Request For Information RFI-097

Subject: BP3 Art and Brand Wall Supplemental Steel
Project: Steamboat - BV BP Promenade and Goldwalk
Address: 2305 Mount Werner Circle
Steamboat Springs CO 80487 USA
Phone:
To: Bryan Sculthorpe
Saunders Construction, LLC
From: Saunders Construction, LLC

Ref attached correspondence and bootleg drawings sheets, the supplemental steel for the Goldwalk and Artwall is required to be included in BP3 Goldwalk scope.

1 BRAND WALL SECTION
1/2"=1'-0"

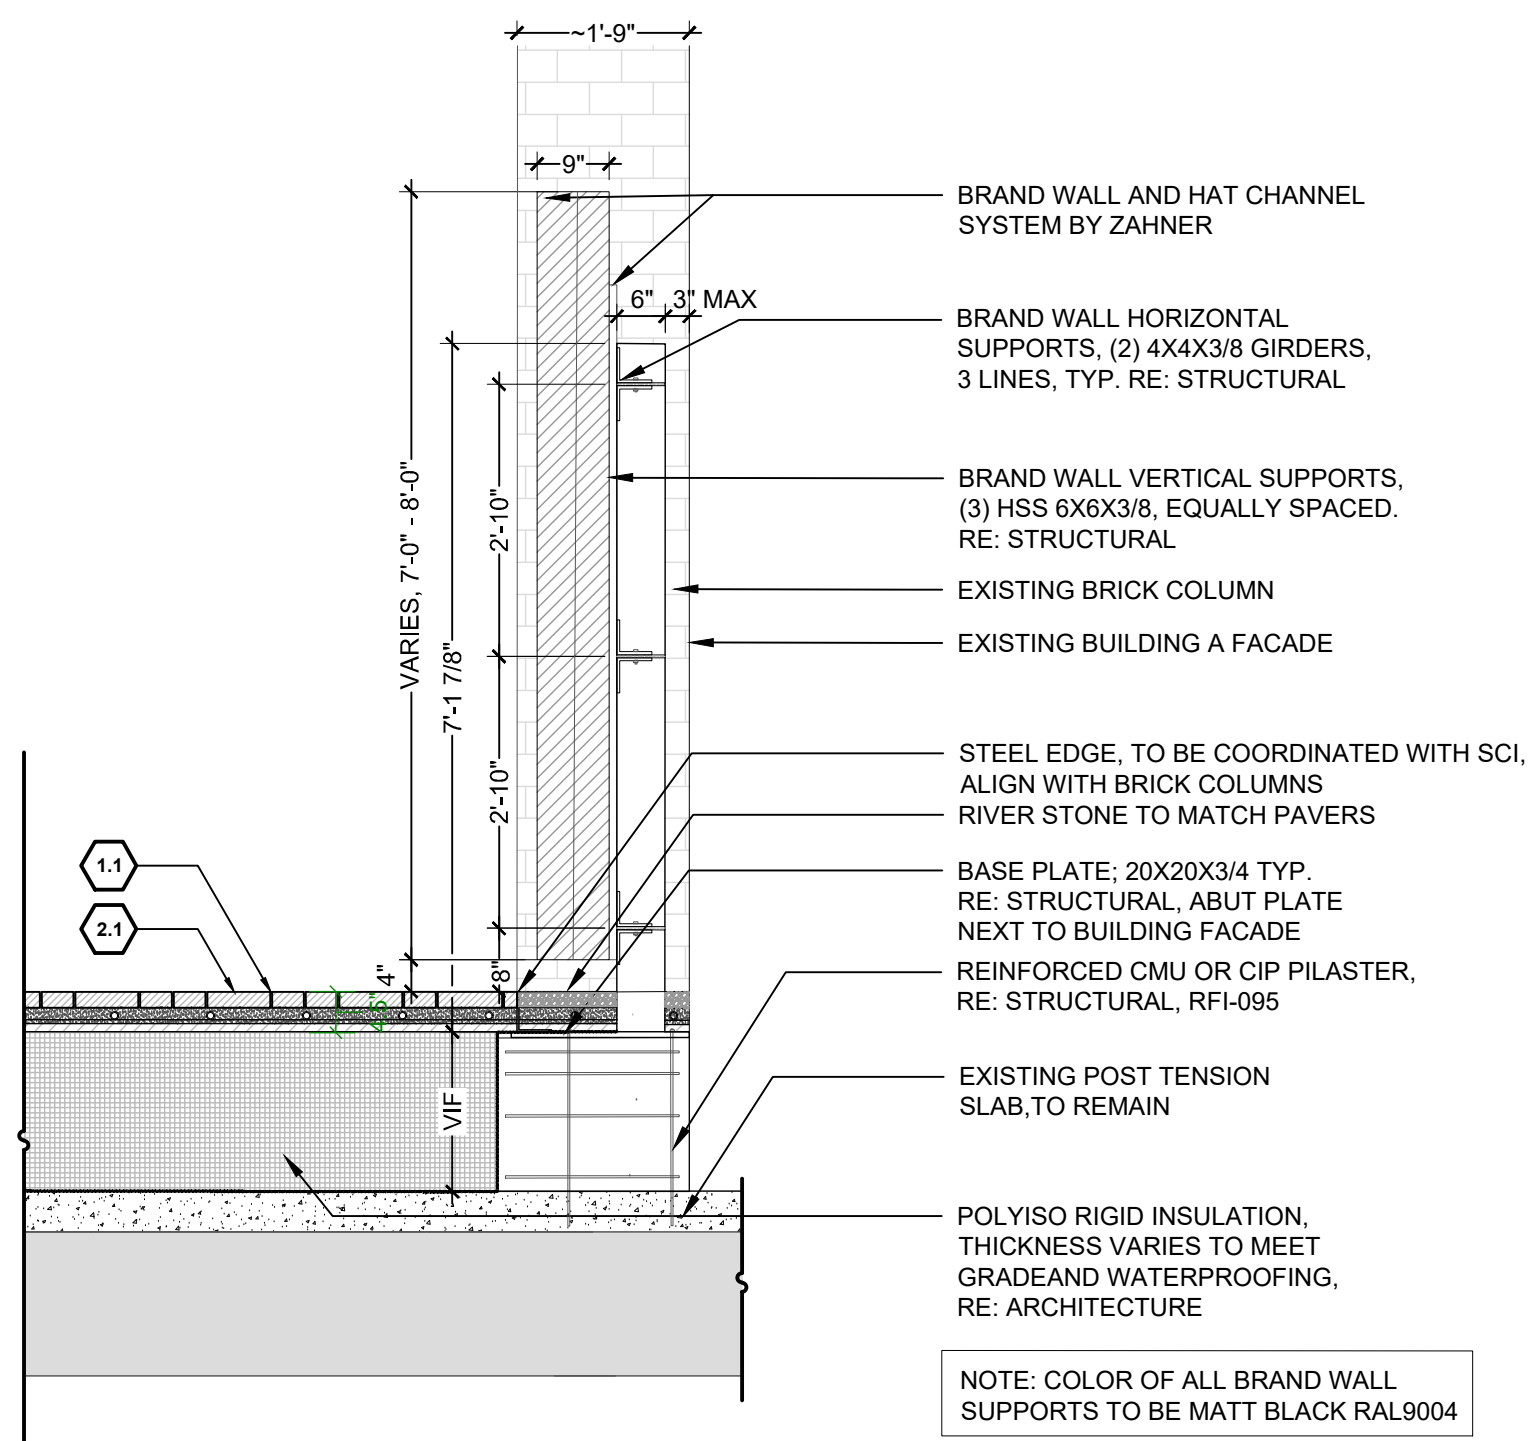
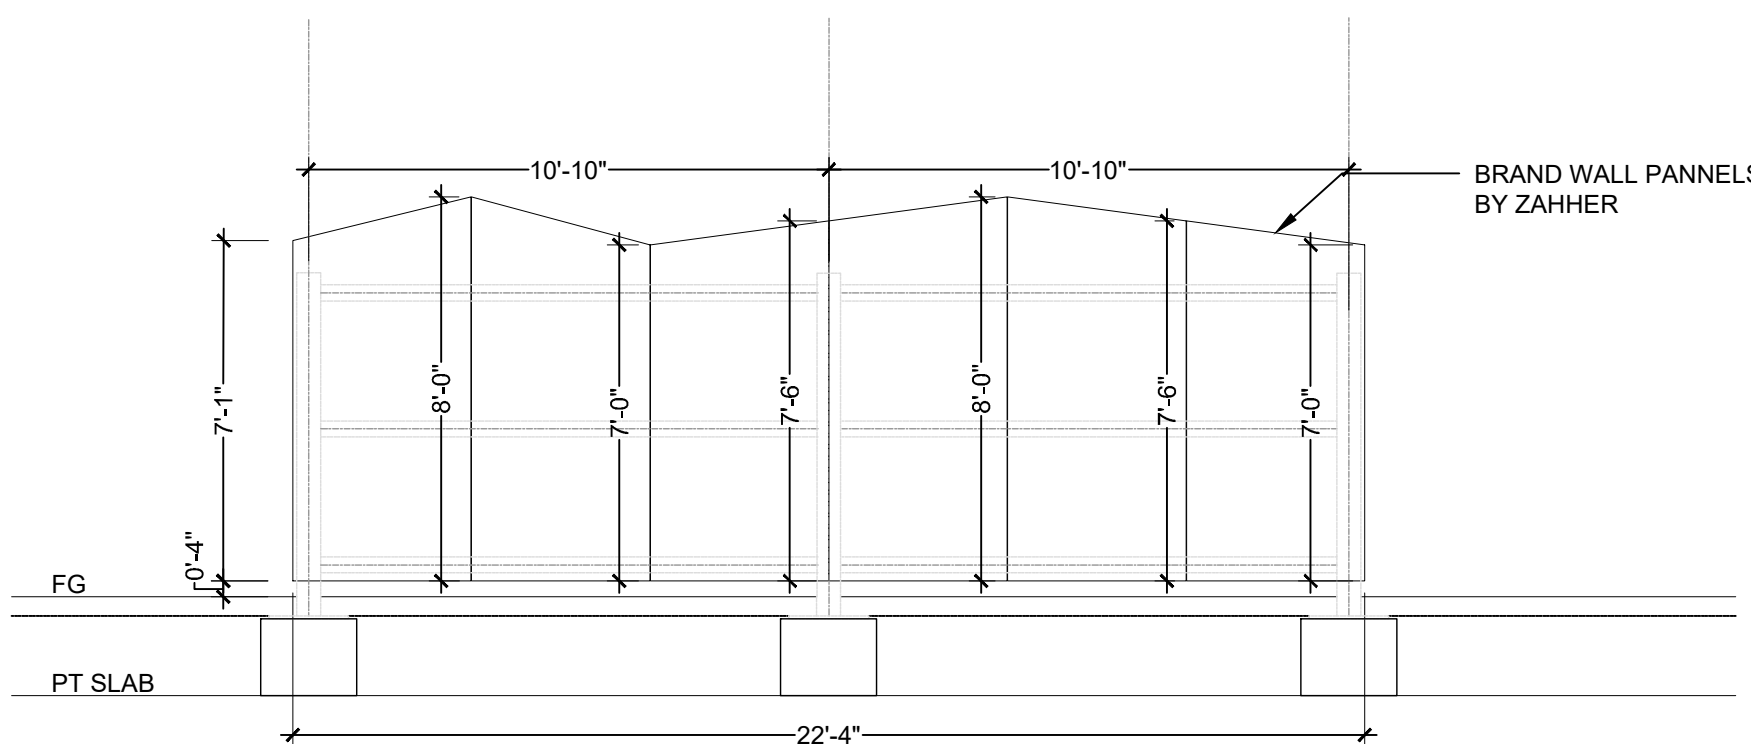
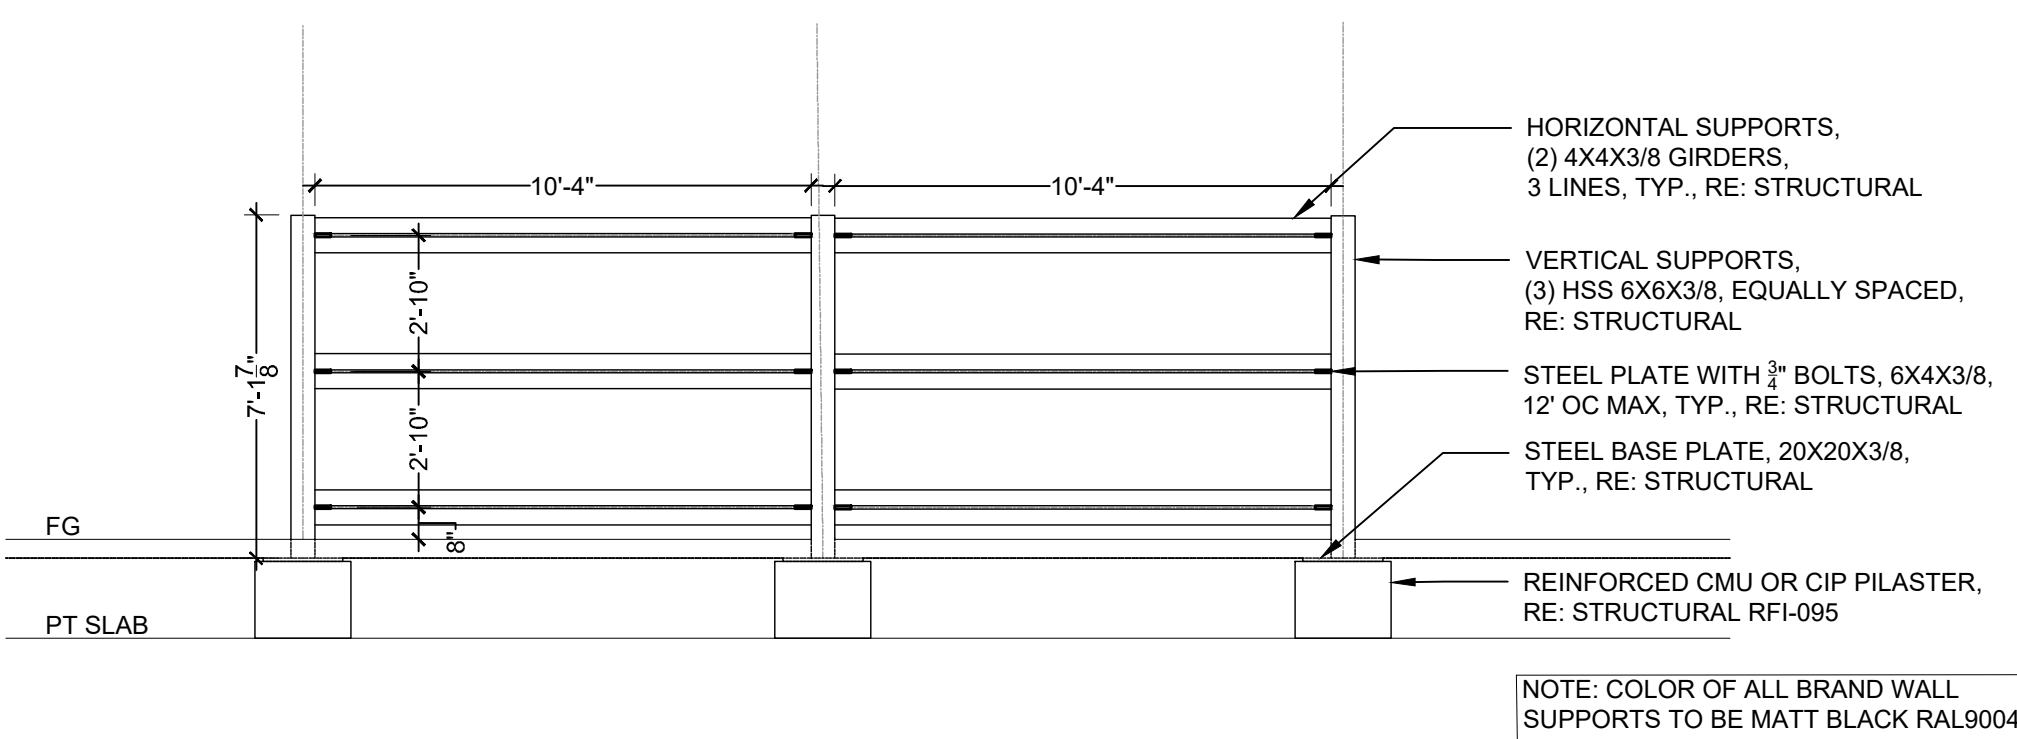
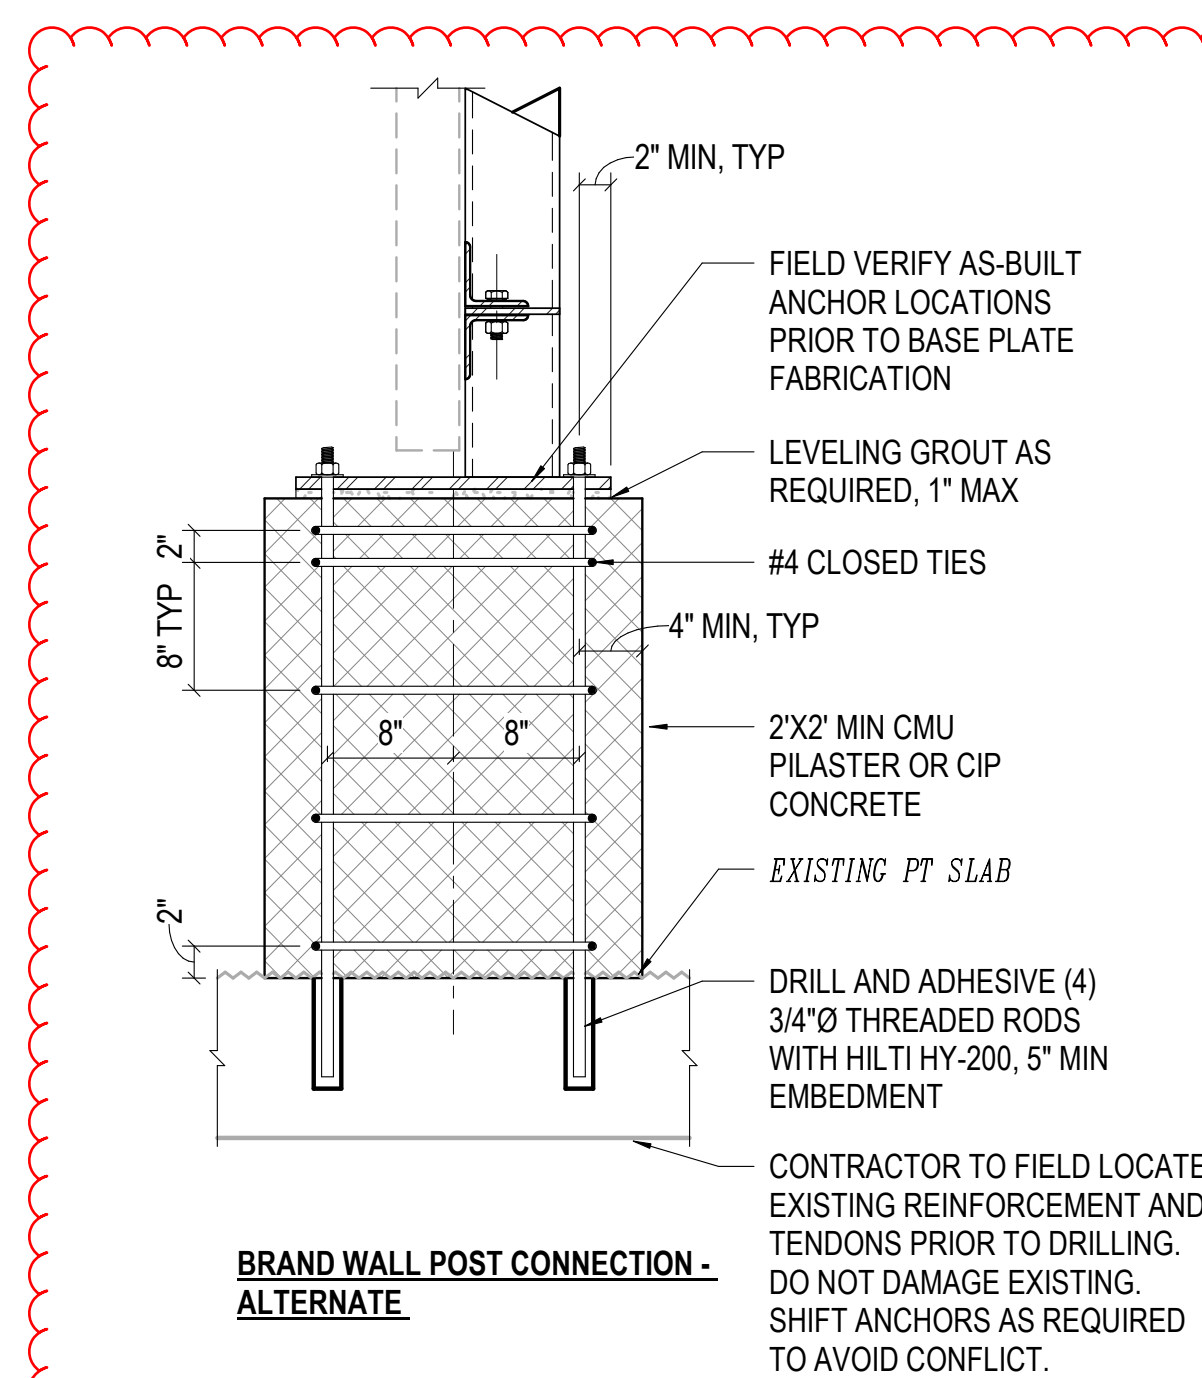
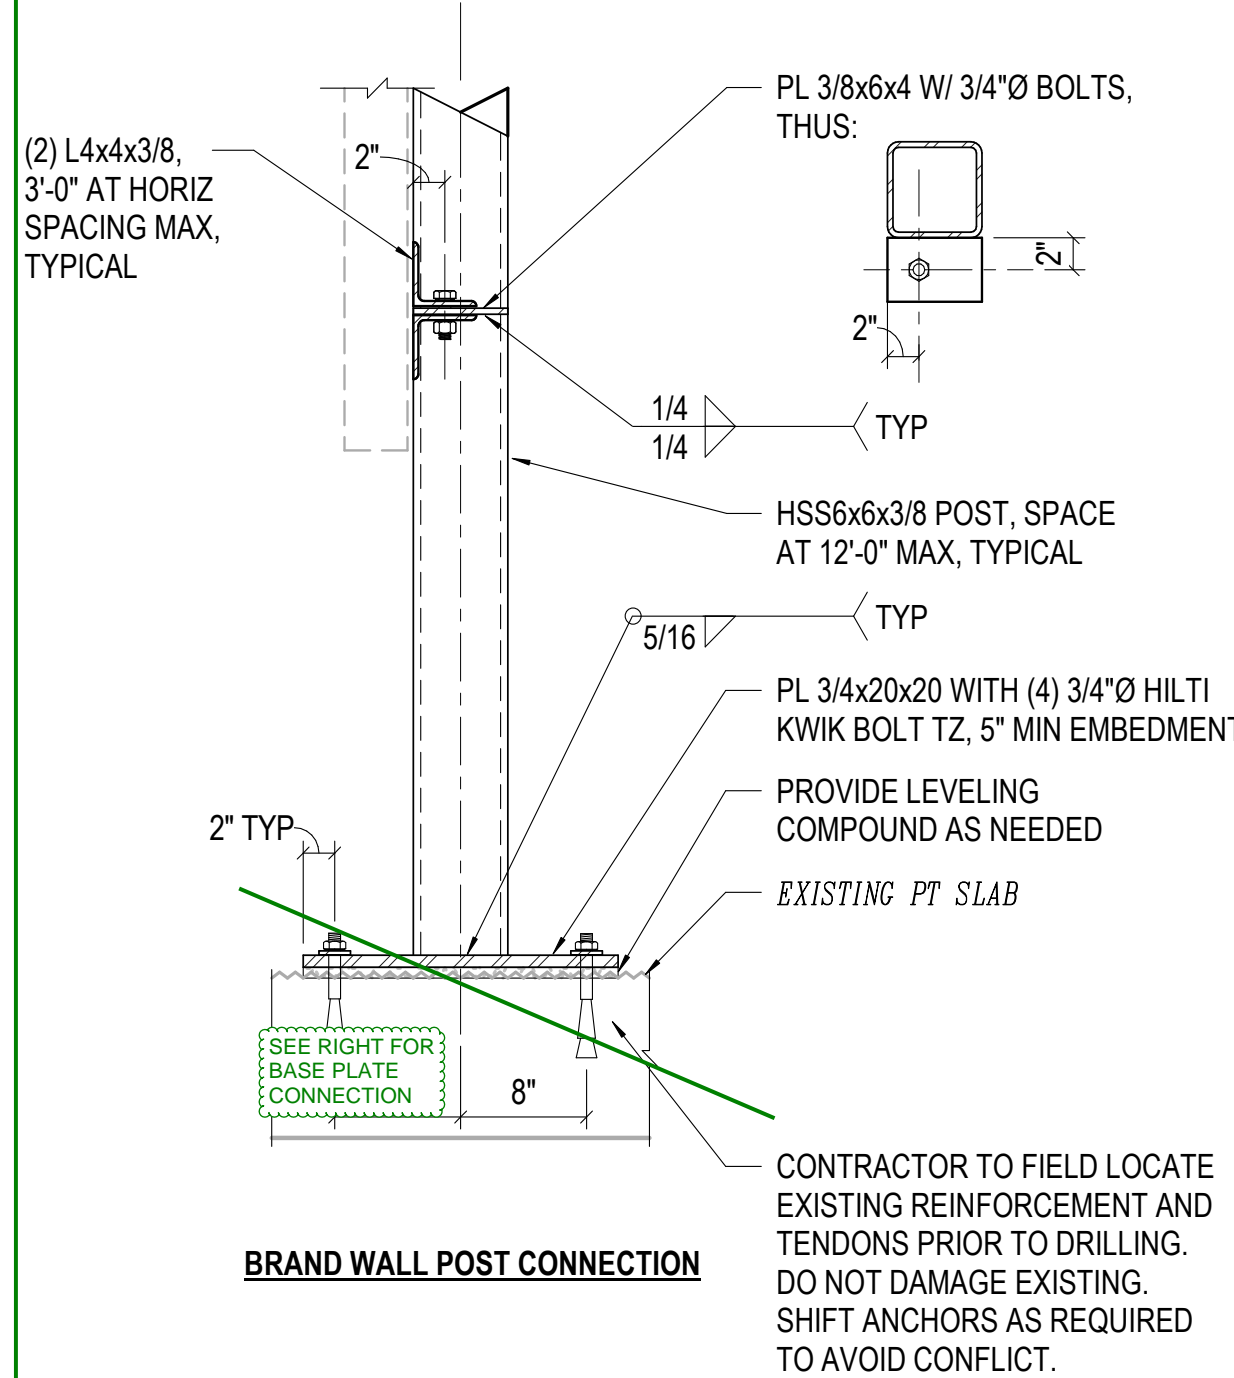
Please confirm bootleg supplemental steel package should be included in scope. If so- please provide updated construction documents that are reflective of additional supplemental steel required.

DW HAS UPDATED OUR BP3 GOLDWALK DRAWINGS TO REFLECT THE REQUIERED SUPPLEMENTAL STEEL TO SUPPORT THE ART AND BRAND WALLS. ADDITIONALLY, WE HAVE UPDATED THE LIGHTING SCHEDULE AND LIGHTING PLAN TO INCLUDE THE F6 FIXTURES. REVISED DRAWINGS INCLUDE: L0-04 GENERAL INFORMATION, L3-01 MATERIALS PLAN, L4-01, L6-01 LIGHTING PLAN, L7-02 ART WALL DETAILS, L7-03 BRAND WALL DETAILS.
SCARROLLA, DW, 10/01/21

M/M detail provided 9/30/21
